2021 Code Changes

NSPC & ICC CODE CHANGE Update

2021 and 2017 Codes

Figure 6.2
A GREASE INTERCEPTOR SERVING A TRAPPED AND VENTED FIXTURE

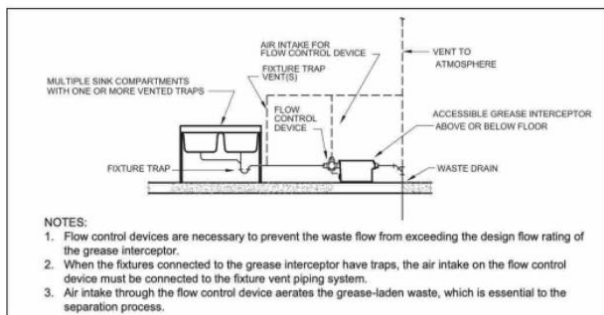
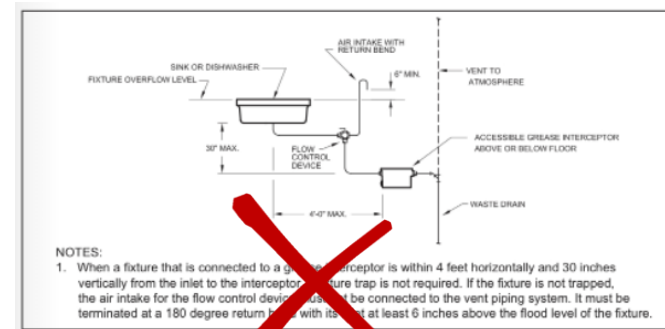
Eliminated Figure 6.2-B to conform with the removal of the “Exception” (e.g., grease interceptor is not a trap.)

Figure 6.2 (previously Figure 6.2-A) remains in the 2021 NSPC
